CITY OF PROVIDENCE, RHODE ISLAND

RFP Title: Municipal Roof Replacement at 552 Academy Avenue

Addendum #: 2

Issue Date: 10/10/2025

1 ROOF PLAN
A-100 SCALE: N.T.S.

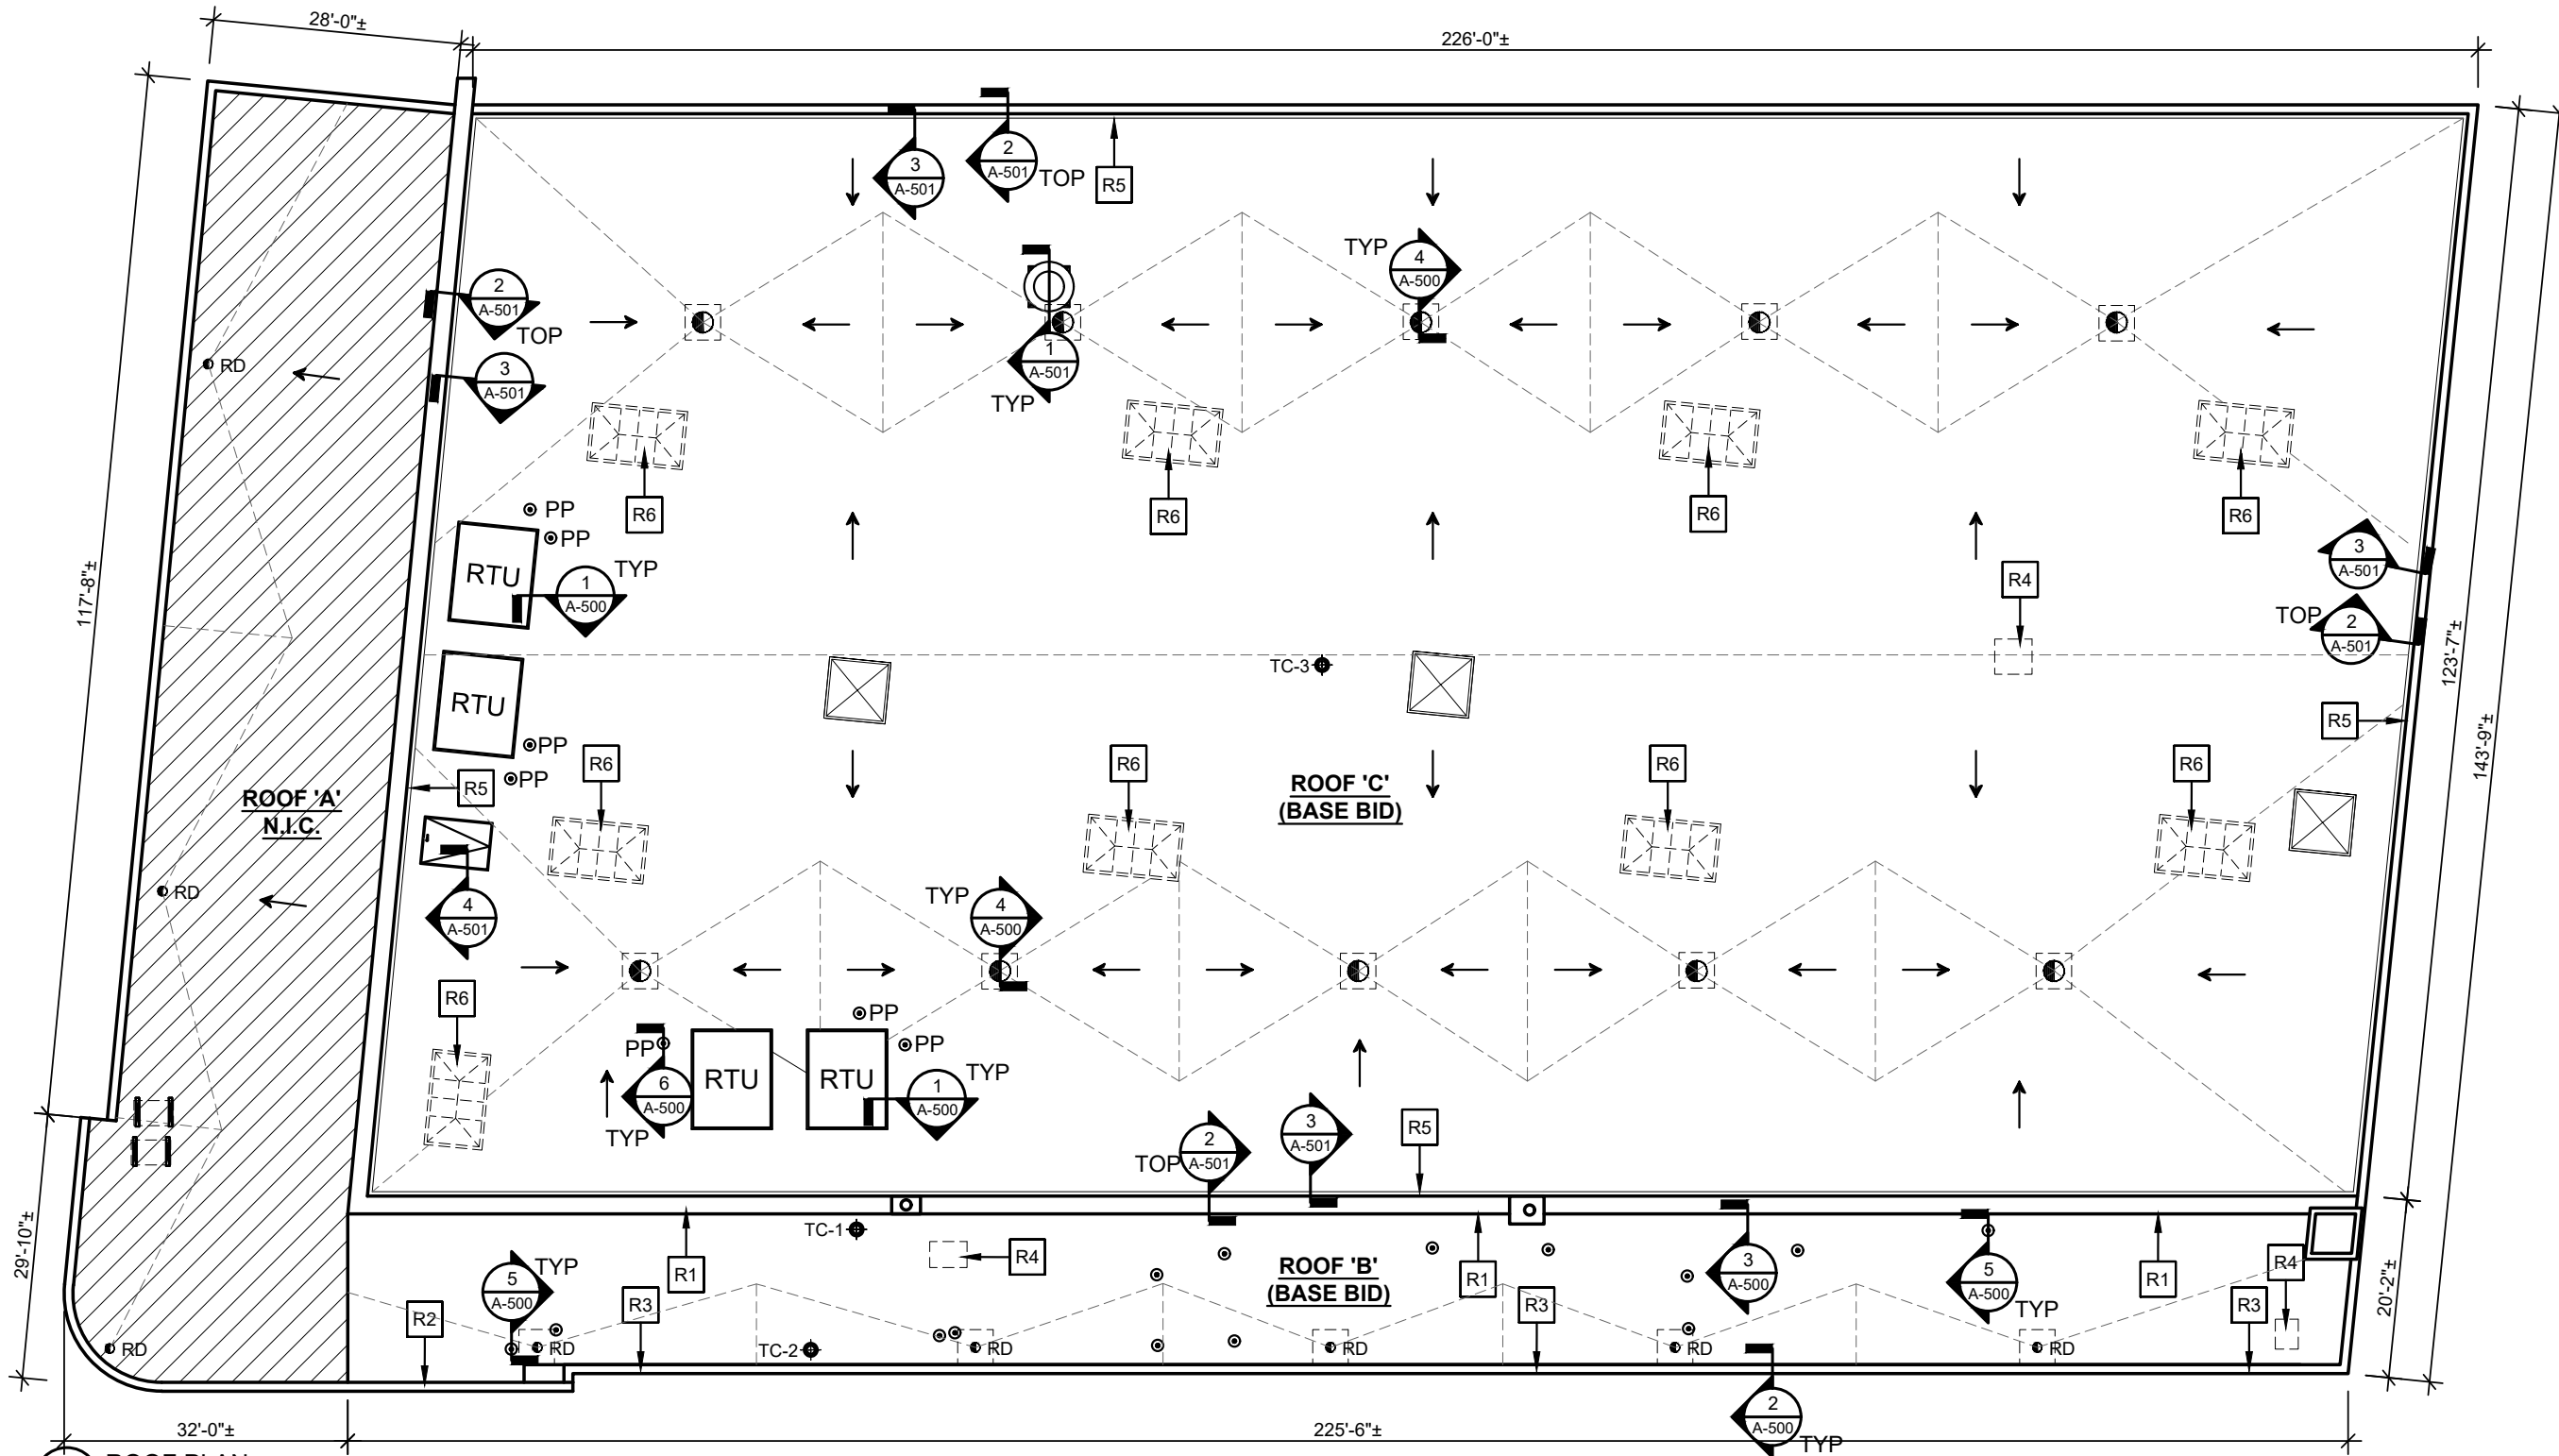
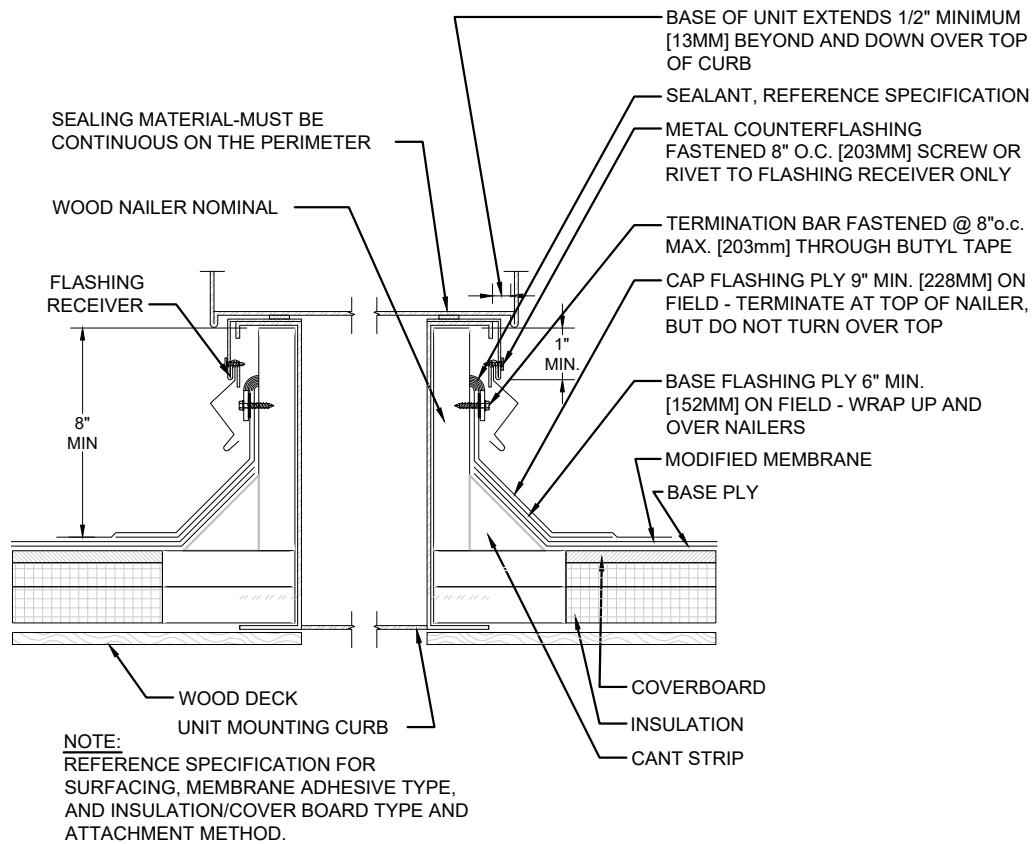
- a. Contractor will be responsible for disconnecting and reconnecting any operable mechanical equipment on the roof.
 - b. Contractor will be responsible for removing obsolete roof equipment identified on revised A-100.

- a. Office space will be provided within the building.
6. Please clarify the base bid vs. alternate. Drawing cover A-001 depicts Roofs B& C as base bid. However A-100 depicts Roof 'C' as Base Bid and Roof 'B' as alternate. Please confirm base bid vs. alternate.

- a. Both roofs are included within the Base Bid, and all drawings have been updated accordingly.
7. Details on A-500 are not keyed or coordinated to the roof plan, A-100. Please provide locations / clarification.

8. Details 1&4 on A-501 are not keyed or coordinated to the roof plan, A-100. Please provide locations / clarification.
 - a. See revised A-100, A-501.
9. Please confirm roof structure is sloped and tapered insulation is only required at the roof crickets.

- a. Correct
10. Please locate pitch pockets on the roof plan if required.
 - a. Please see revised drawings indicating pitch pocket locations.
11. We are assuming that the existing roof planks will be reused after the existing roofing is removed. If it's intended that this be replaced as required, please provide an allowance to be carried for replacement by all bidders.

- a. See revised A-100, A-500.

- R1 REGLET TO BE RAISED ON ENTIRE WALL
- R2 COPING AT PERIMETER
- R3 R-MER FORCE WITH EXTENDER. ADD BLOCKING
- R4 OBSOLETE ROOF EQUIPMENT TO BE REMOVED
- R5 METAL PANEL ON WALL. SEE DETAIL 3/A-501.
- R6 REMOVE EXISTING SKYLIGHTS IN ITS ENTIRETY. INFILL EXISTING OPENING WITH ADJACENT INKING MATERIALS
